1 **ADDENDUM NO. 5**

2 **ISSUE DATE: June 18, 2018**

3
4 **RE: GOODMAN SOFTBALL LOCKER ROOM REMODEL**
5 **UNIVERSITY OF WISCONSIN, MADISON - ATHLETICS DEPARTMENT**
6 **MADISON, WISCONSIN**
7 **UW-Madison Project No. MSN-0175-1701 / UWSA Project No. A-17-008**
8

(Firm Name)

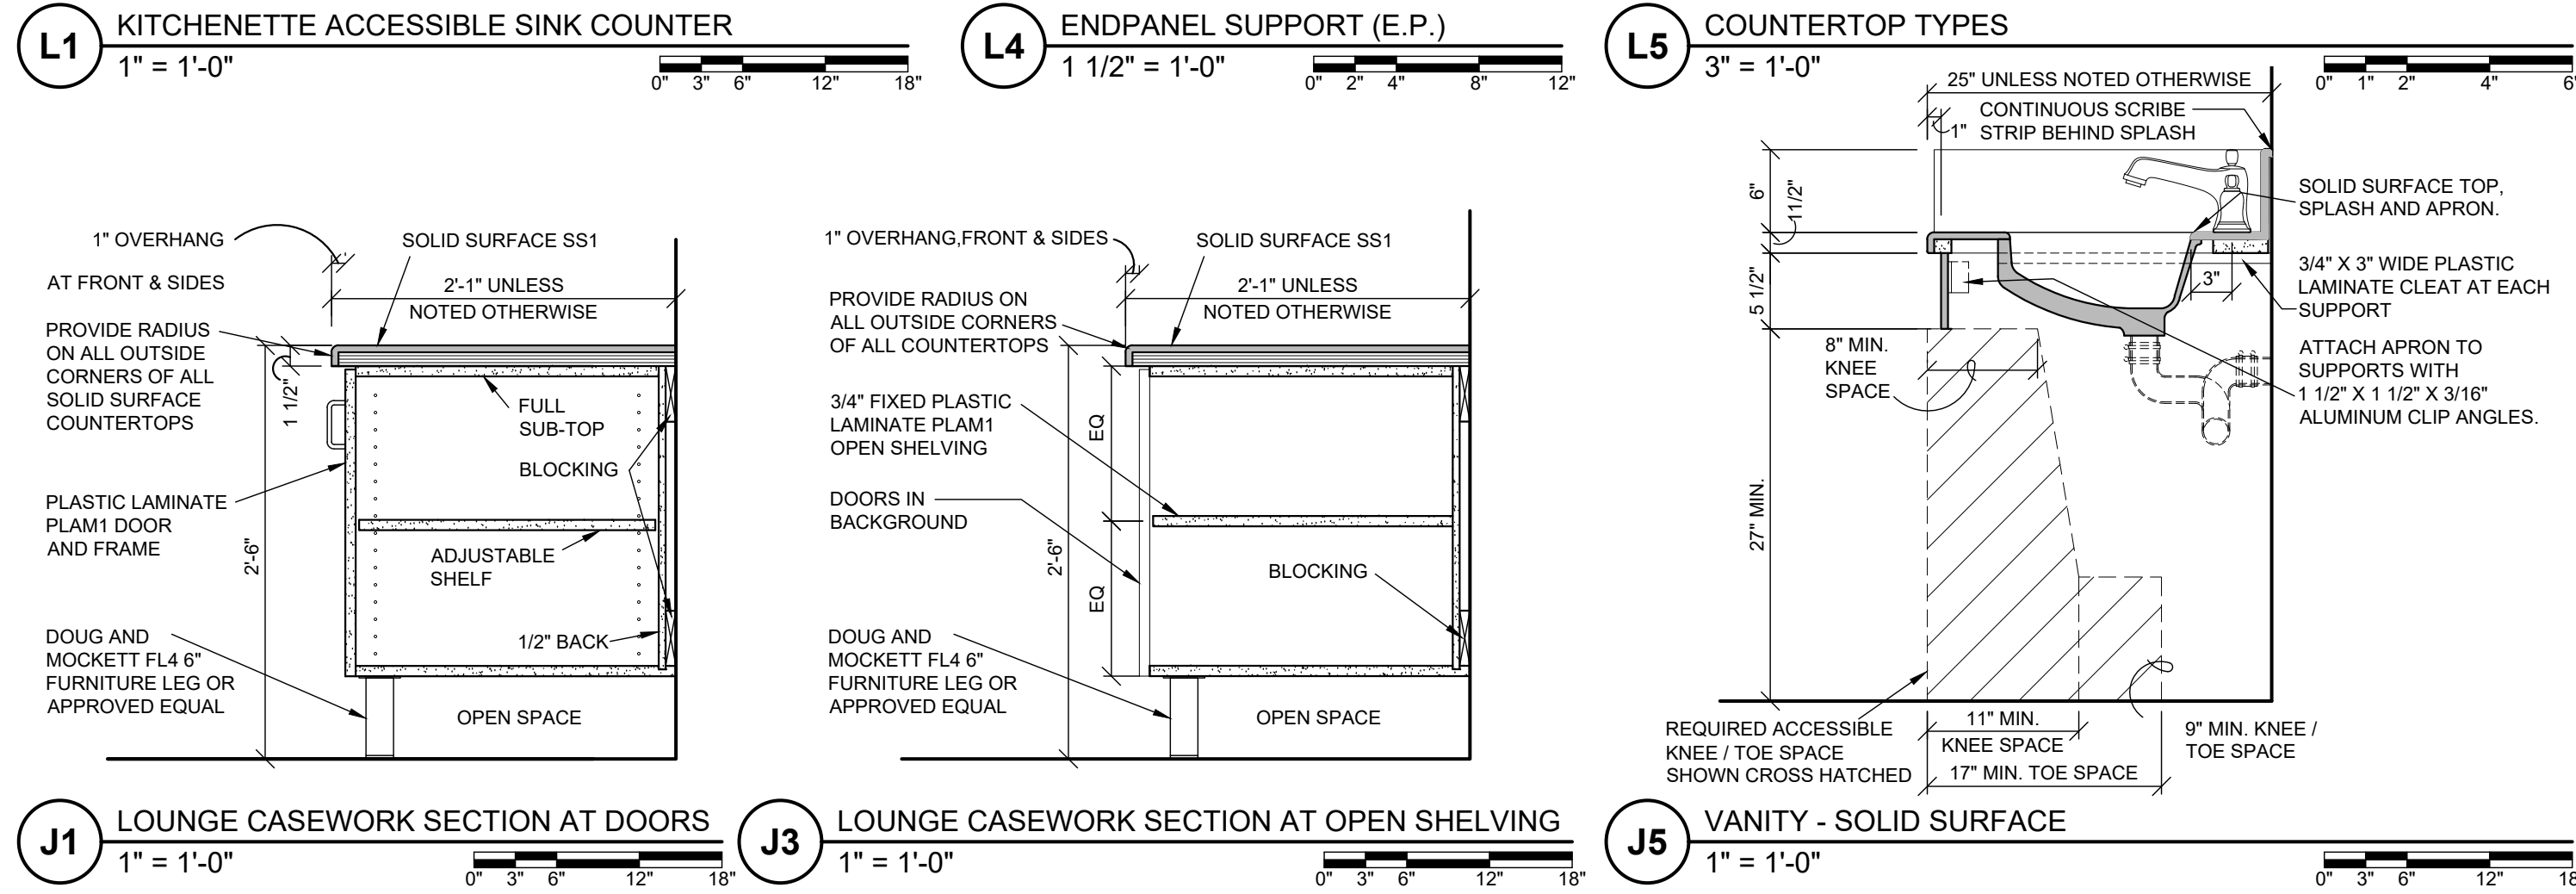
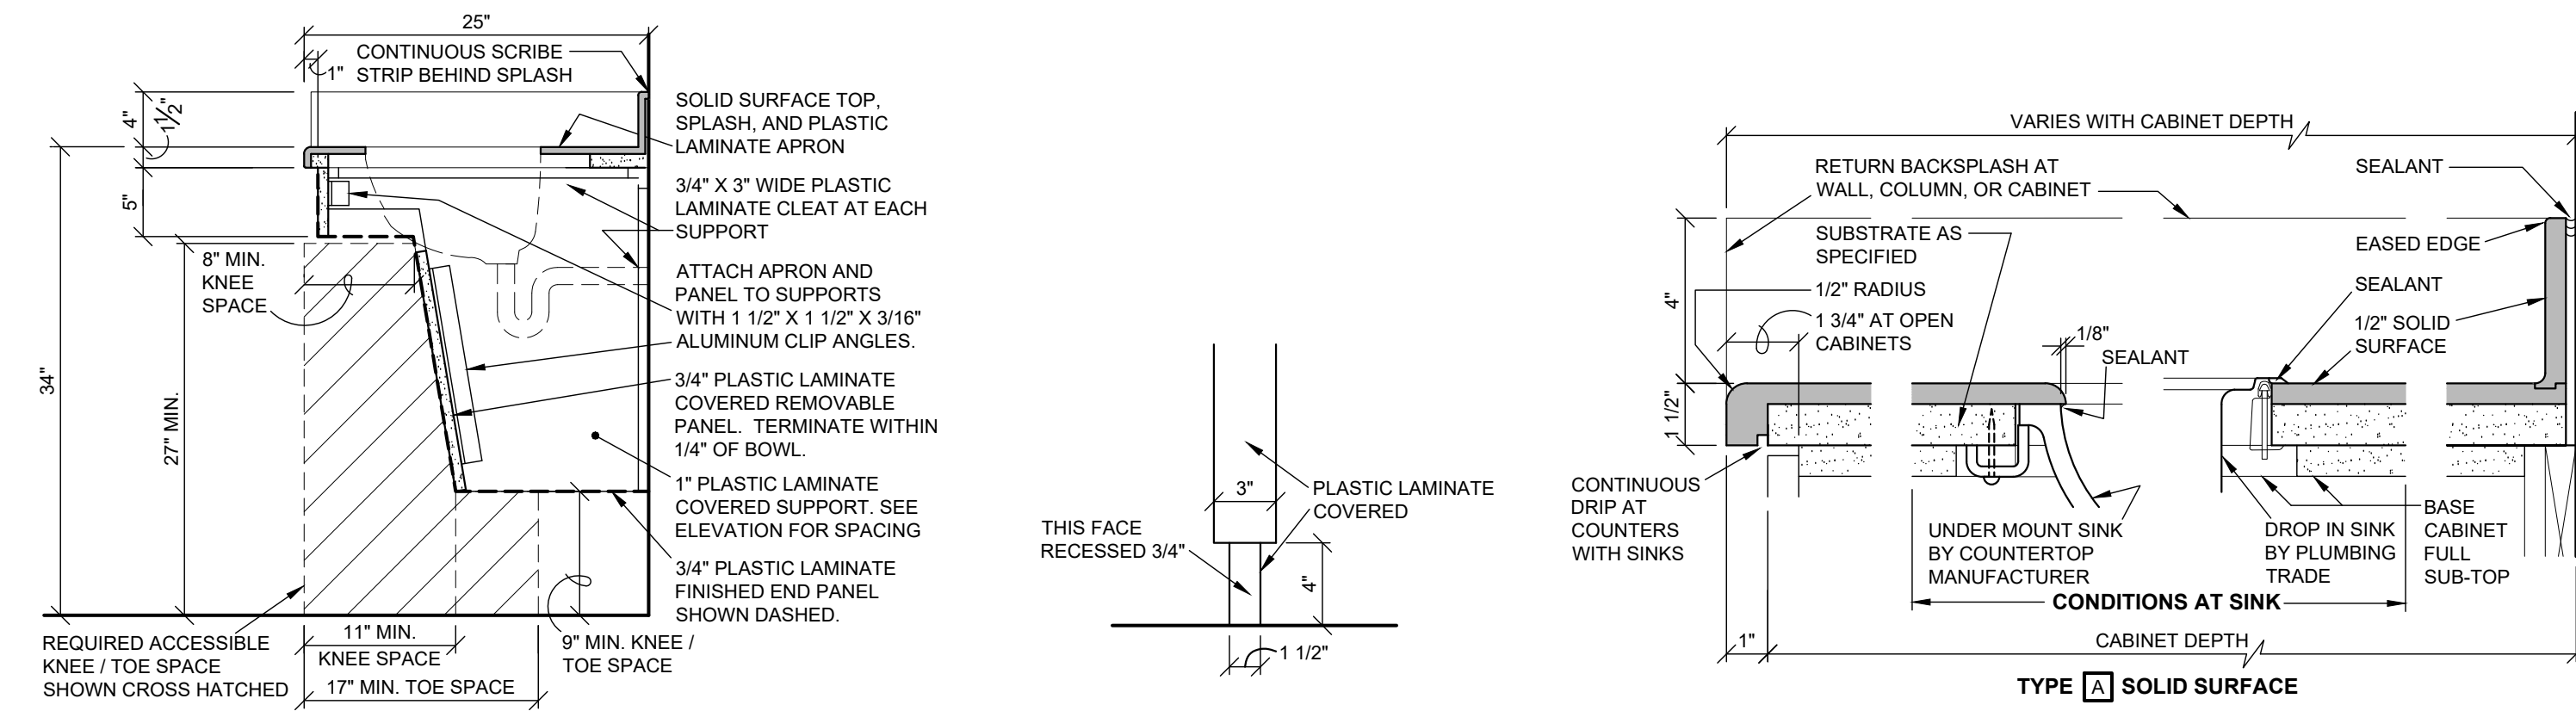
30 6. QUESTION: Sheet A401, details E6, E8, E10 show a Metal Mesh Panel System in the Mudroom.
31 Detail A1/A701 gives some specifications for how these are constructed, although there doesn't appear to
32 be anything in the specifications. Plan E13/A401 - Enlarged Basement Floor Locker Room shows the
33 Mudroom Metal Mesh System as being existing. Please clarify.
34

A. Page 05 50 00-1, line 11, add: "Furnish and install metal mesh panel system."

Fabricate panels and mounting brackets as noted on drawings. All fasteners shall be stainless steel.

Mounting hardware shall be securely anchored through wood blocking located behind the plastic laminate back panel.

35 RESPONSE: Metal mesh panel system in mudroom is new and to be provided by General Contractor in their
36 bids. Existing/Owner-furnished symbols on plan detail E13/A401 are in reference to the seating stools
37 in the center of the room, not the metal mesh panel system.
38
